CITY PLANNING COMMISSION AGENDA

ITEM NOS: 5.A-5.E

STAFF: RICK O'CONNOR

PROJECT: THE RENAISSANCE AT INDIGO RANCH

DEV'T PLAN FIGURE 3

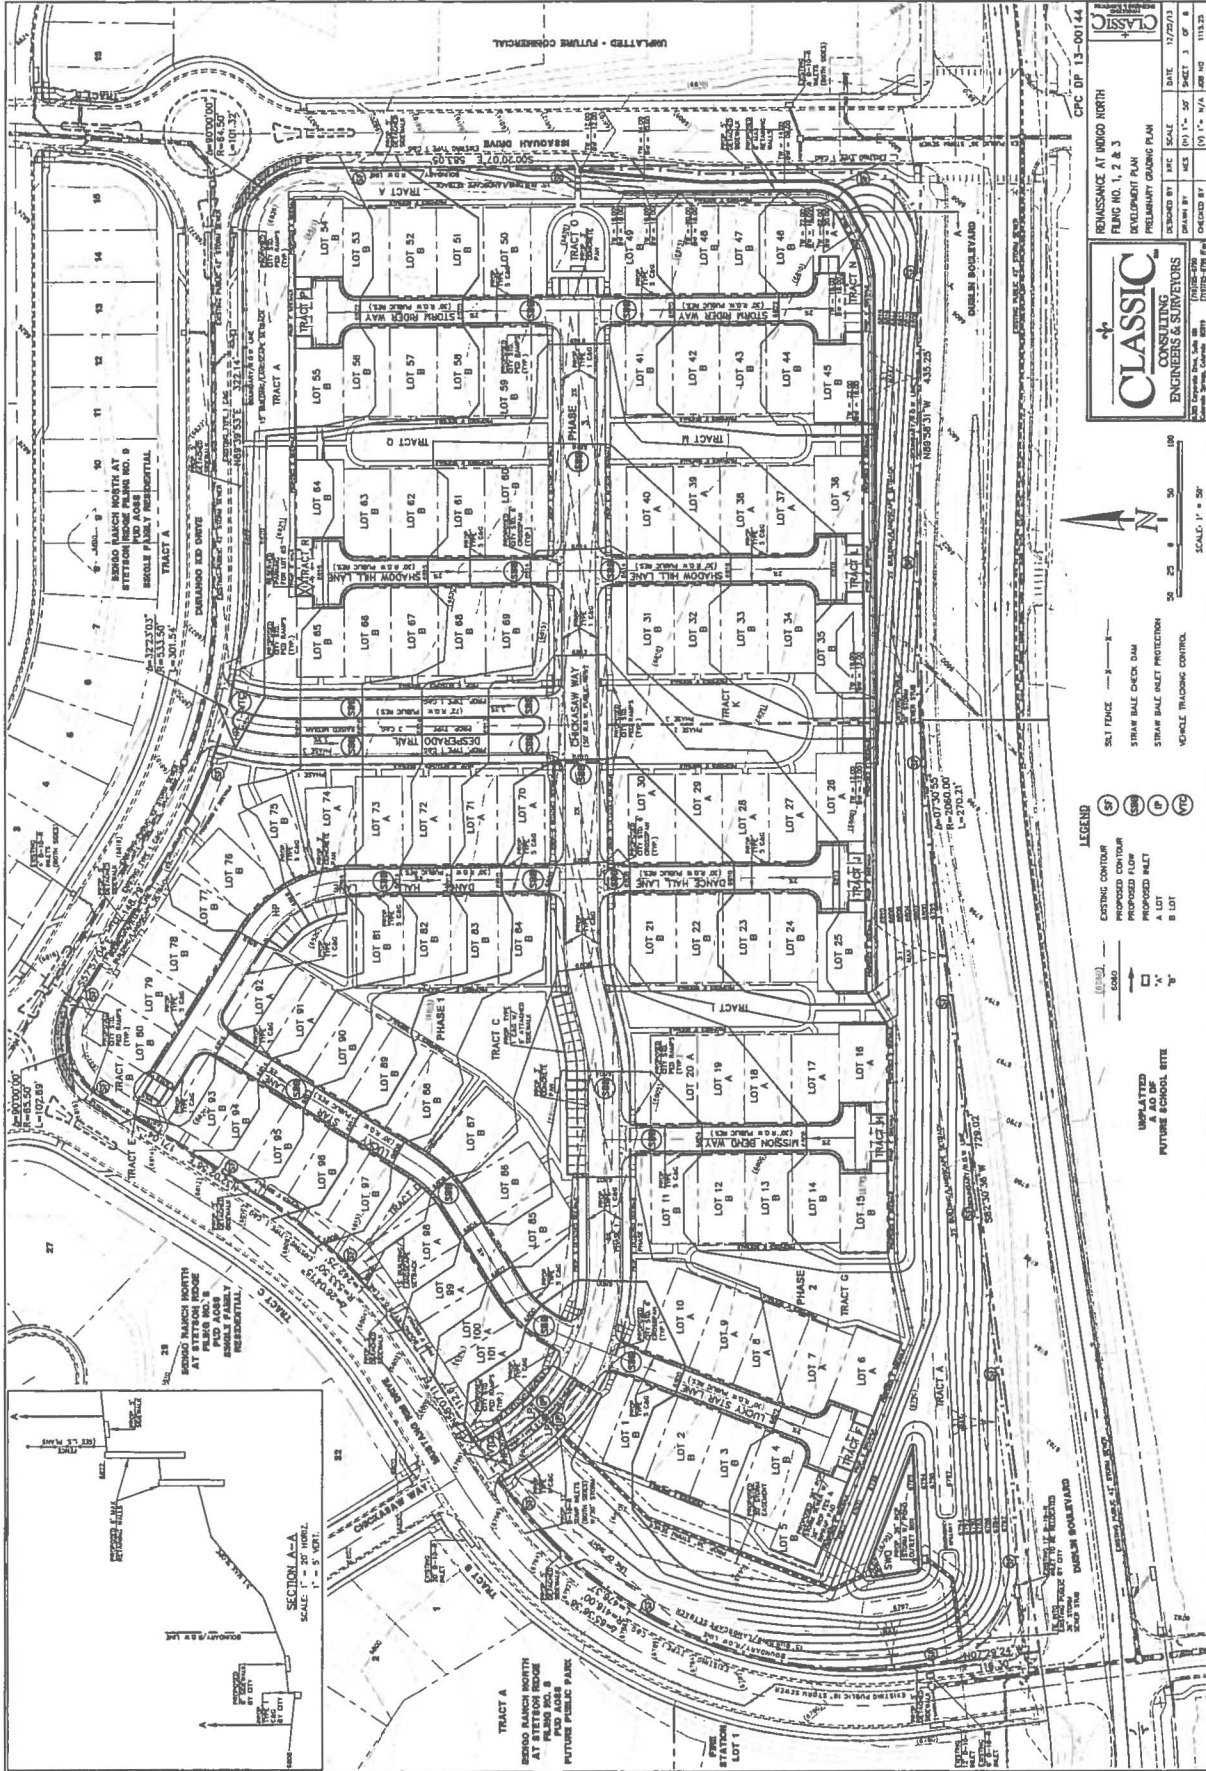
Within Chaparral Point, the internal rear access roadways are continuous and connect with a looped system. Within this proposal, many of the units are accessed with dead end streets (called "access" streets with a 22 foot mat/27 foot width to back of curb); however the number of units being served by the dead end streets is limited to not more than 10. The dead end streets do reduce the amount of pavement and provide adequate access to the units. City Engineering and Fire support this concept as public streets.

The second deviation is the number of units that do not actually front onto a greenway. The design manual limits the amount of non-greenway units to 10%; this proposal includes approximately 20% non-greenway units. While the non-greenway units do not have front loaded garages (all garages accessed in the rear), they do orient toward a street instead of a greenway. The minimum greenway width called out within the manual is a 40-foot width. Many of the units that do not face the greenway are along the two adjoining collector streets, Mustang Rim and Issaquah Drive.

Noise issues are one of the review criteria that deserve discussion. The typical standard to address noise is the construction of a noise wall and additional setbacks. While the setback area for this development is significant adjacent to Dublin, the applicants are not installing a noise wall and the grade actually rises from the road to the finished units. Instead, the applicants had a noise study completed to address this issue. Apparently the results indicate that additional soundproofing is necessary for those dwellings adjacent to Dublin. Staff has requested a copy of the study and a proposed technical modification below is suggested to update the development plan to address the necessary noise mitigation.

1. Sound study information from LSC was not provided. The development plan needs to include information as to specific units that are subject to additional sound attenuation. Provide a copy of the study and indicate on the development plan the affected units and the necessary noise mitigation.
 2. Provide a detail of the retaining walls (materials).
 3. Address the items noted by the Landscape Architect consisting of the following:
 - a. Include all street names and classifications on the landscape plan.
 - b. Show all Landscape categories requirements (setbacks, internal, and buffers if there are commercial uses across the non-arterial).
 4. Provide a letter from the Metro District which indicates that they will accept all responsibility for the ownership and maintenance of properties as noted on the plan.
-

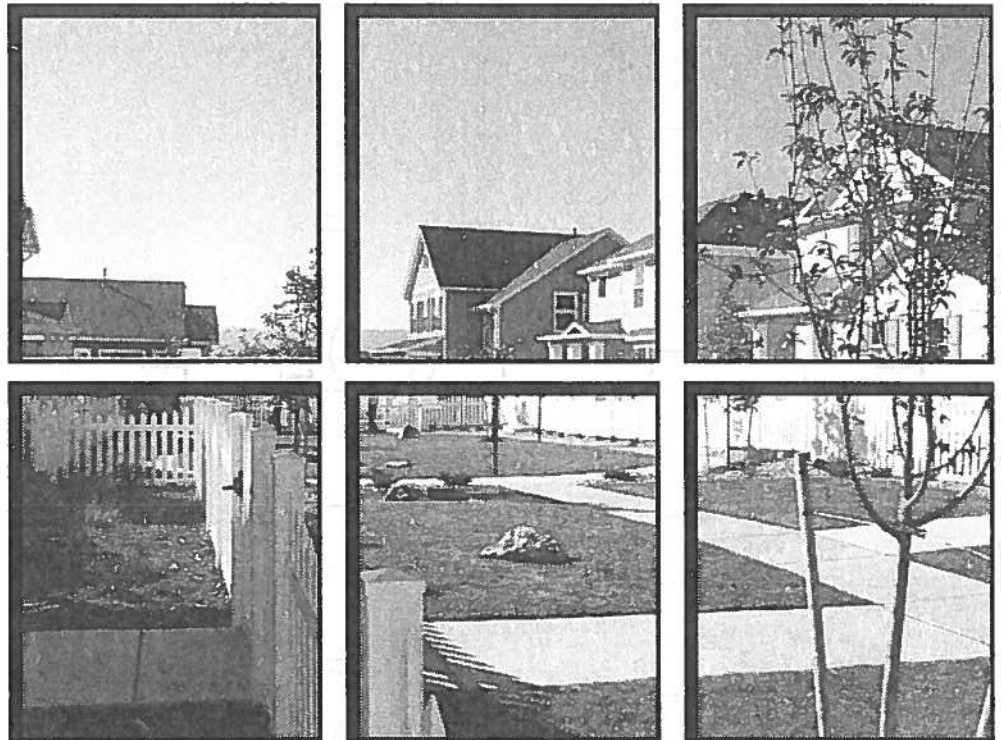
Based on our calculations, approximately 36 elementary, 14 middle school, and 25 high school students would be generated from this preliminary plan. Ridgeview Elementary School, Skyview Middle School and Vista Ridge High School currently serve this area. Capacities and recent enrollments of these schools are:

<u>School (Grades)</u>	<u>Student Capacity</u>	<u>Enrollment (10/01/13)</u>	<u>Seats Available (Short)</u>
Ridgeview	600	720	(120)
Skyview Middle	900	1022	(122)
Vista Ridge High	1200	1,230	(30)

Capacities of the schools that will serve this proposed development have surpassed their design limit. Accelerated residential growth and strong growth potential heighten the School District's concern regarding its ability to provide adequate educational opportunities.

Falcon School District does not currently have any capital funding available to build or expand any of our current facilities. We have been unsuccessful with the last few attempts to pass a Bond or Mill Levy Override. Further, on a per pupil basis, District 49 is the second lowest funded District in the State. This and the failure to pass a Bond measure create the inability to fund school construction.

Based upon our calculations, land dedication is not feasible from a development of this size. District 49 cautiously approves the Zoning Change, with the clear understanding of the infrastructure capacity being inadequate and requests that the developer agree to pay cash in lieu of land at the current market value of land within the District. The District would like the opportunity to respond to any land use changes associated with this project.
